August 27, 2023

Dear Arlington Zoning Board of Appeals,

We are the homeowners of 218 Pleasant Street, and together with our neighbors, we strongly oppose the project being proposed at 212 Pleasant Street. We expressed many concerns earlier when Nellie and Mark first submitted a request for a special permit back in February. We have attempted to communicate with them multiple times since then, and still, we haven't received information for all of the changes they are proposing or answers to our concerns. We were the ones to suggest a meeting when we found out they submitted a new request to the ZBA. We are very frustrated that the plans have not changed and that they are unable to provide information to reassure us that our homes and properties will not be harmed.

Drawing C1.1 Proposed Site Plan submitted by Applicant (magnified)

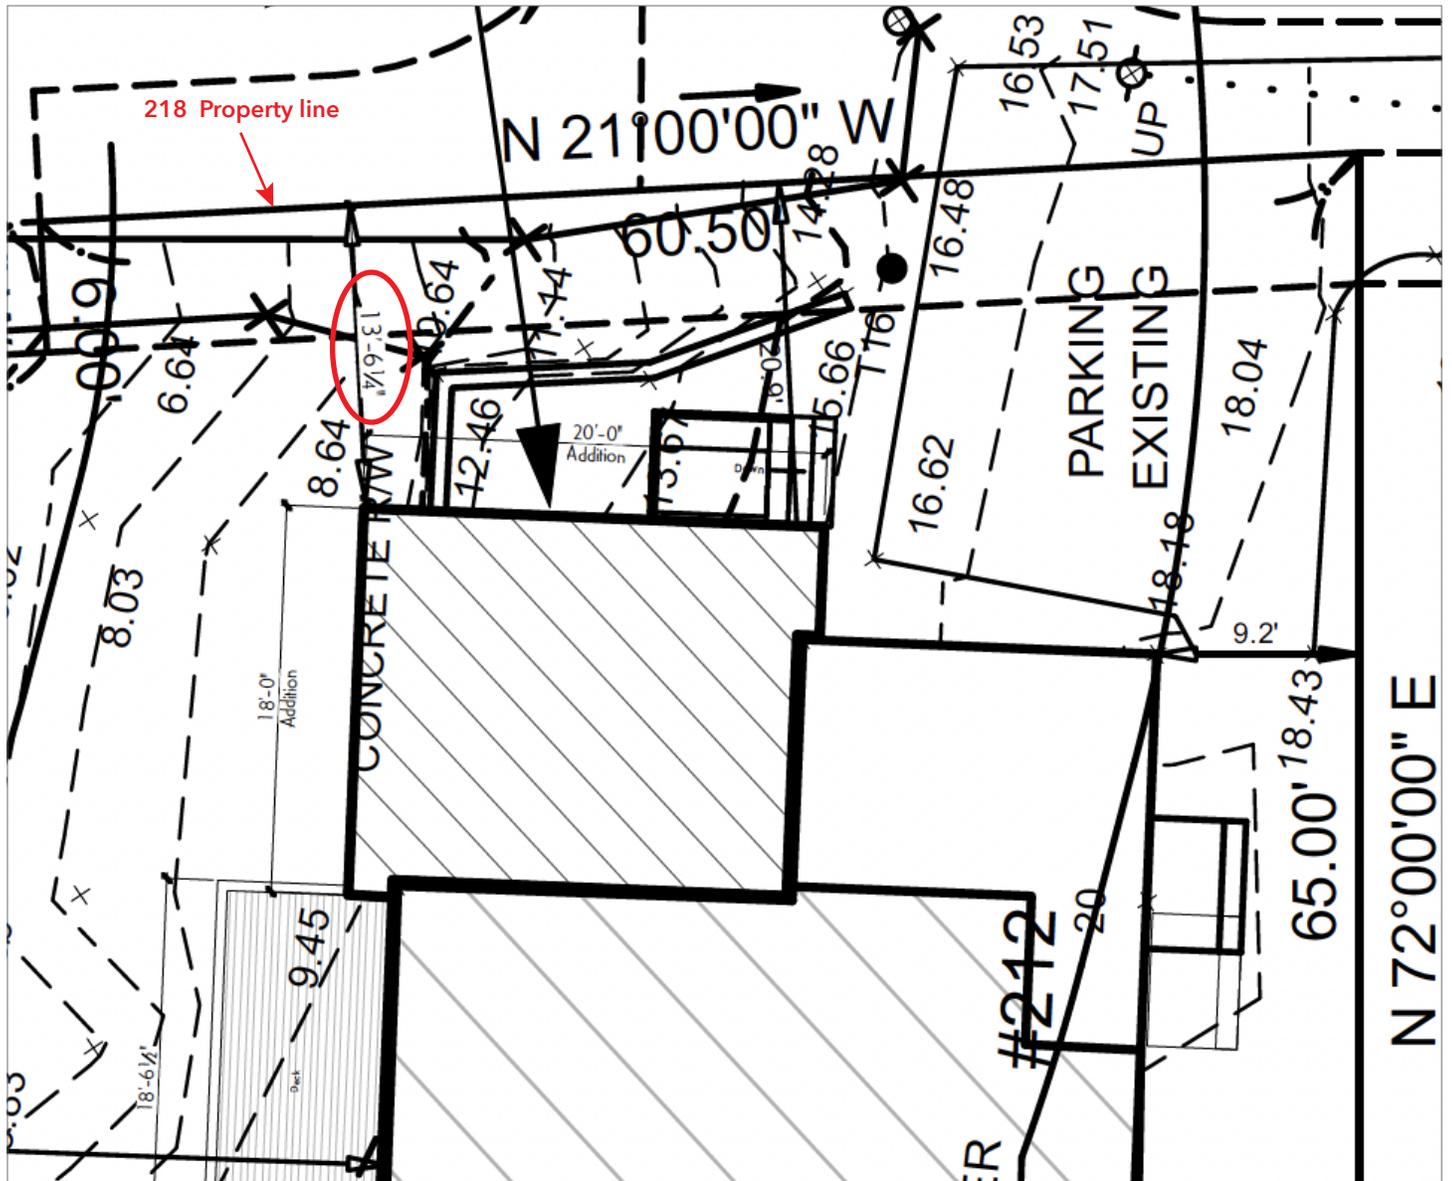
The distance from the proposed house to our property is concerning. On the application, it says the right side yard distance from the existing cottage to our property line is 20' 9" and with the addition this will go down to 15' 6". However, when we zoom into the proposed plot plan, we see 13' 6" as the distance from the proposed house to our property (See Attachment A). We'd like to know what is the correct distance? When we are dealing with a very tight space where we are all living very closely, a difference of 2' is a big deal. We would like this figure corrected in the application as well as in the Department of Planning Community Development's memo to the ZBA dated March 24, 2023. We do not feel confident that the application to the ZBA represents the plans correctly.

In the architect's plans, the large addition will have a side porch and steps off the right of the house. We are not sure whether they meet the minimum yard requirements in the bylaw (5.3.9. Projections into Minimum Yards). There are no dimensions for the porch and steps provided in the drawing but it looks like the porch will go out about 5' and including the steps, about 7.5' from the house. We see what might be the side porch on the proposed plot plan but not the steps that go towards our property line. See Attachment C. We would like a clear drawing and measurement to know whether the porch and steps go into the 10' setback required from our property line, and if so, whether they meet regulations.

Supporting Calculations and Documents submitted by Applicant (excerpt)

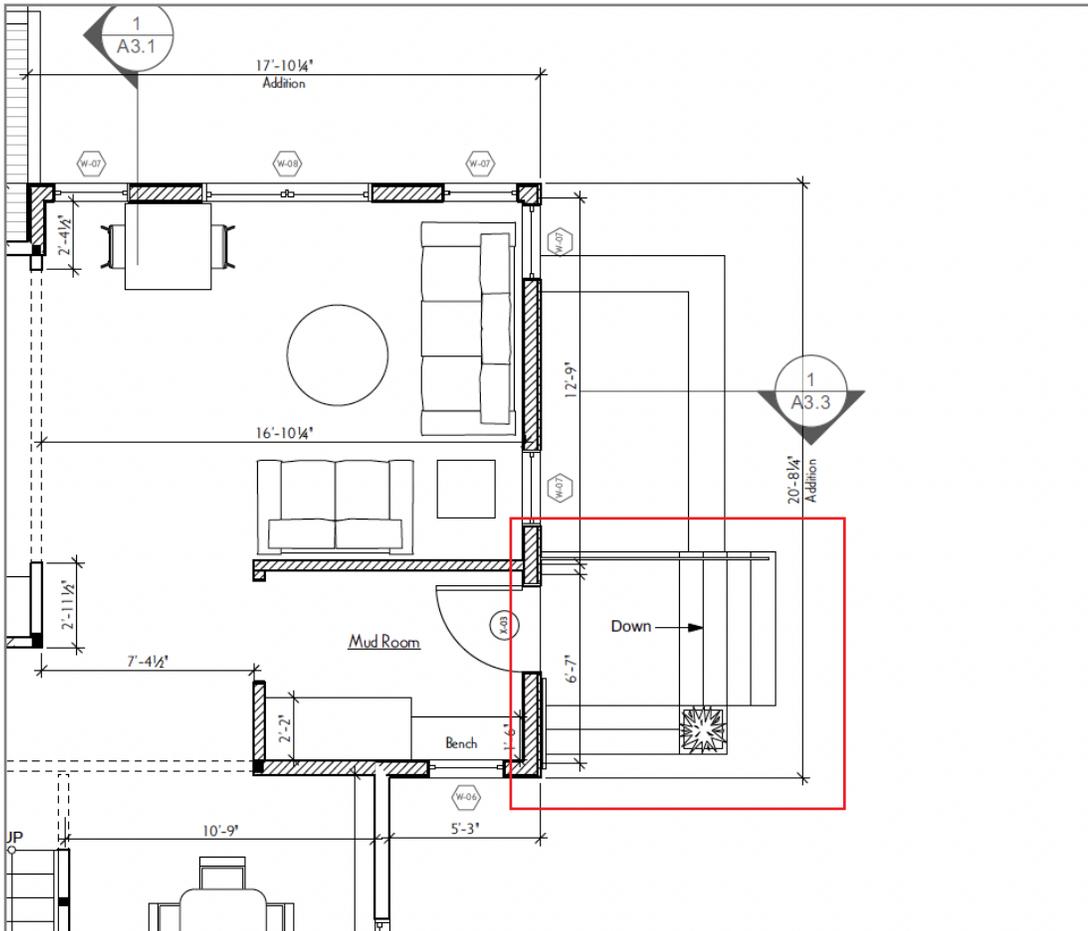
We would like to see the plans for how they are changing the parking area at 212 Pleasant Street. We cannot tell from the existing and proposed plans how it is being enlarged from 480 square feet to 638 square feet. We find this square footage only on calculations of open space but not on plot plans (Attachment B). We have had a survey done and we want to know the bigger parking area is not on our property or blocking 216 Pleasant's easement. We also want to understand what changes to the land will have to be made to make room for the much larger parking space. We are concerned that the applicant cut down a protected tree to create more space. Another worry is how changing the parking area with permeable materials could impact our home. We want an engineer to review complete plans so we are not worried about the water in the ground damaging our property and foundation.

Drawing C1.1 Proposed Site Plan submitted by Applicant (magnified)

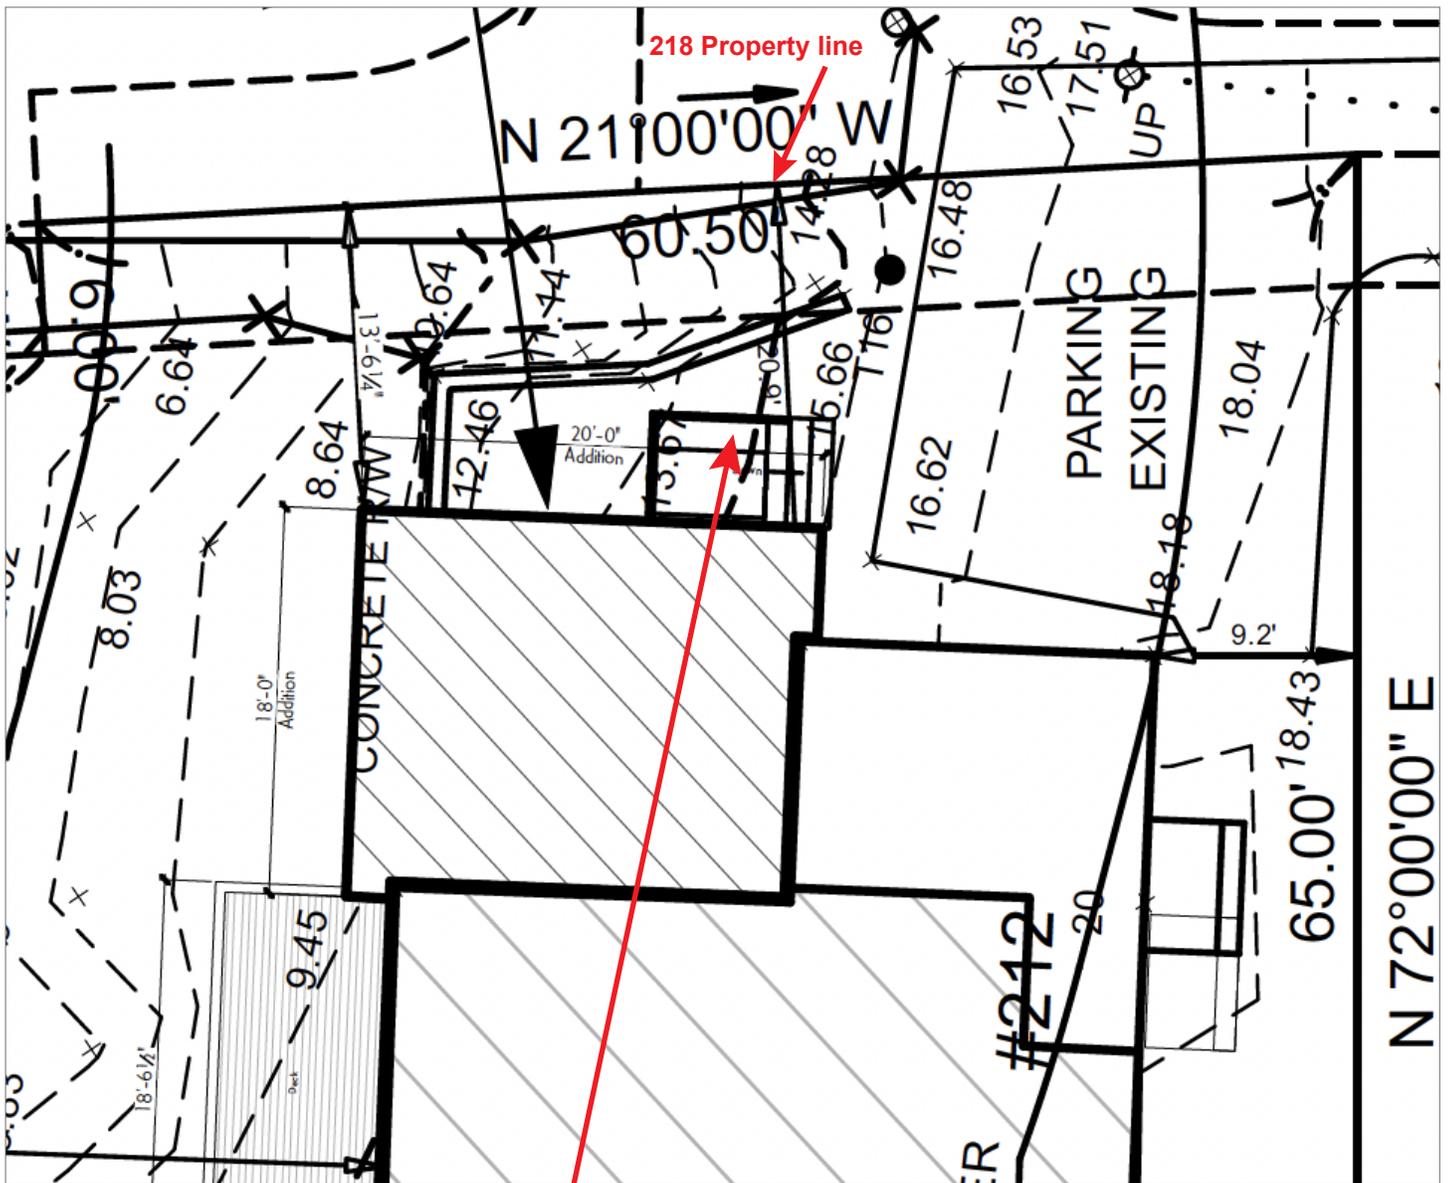
Is this drawing of side porch? Does it include steps going out towards 218's property line?

What is distance from porch and proposed steps to 218 property line?
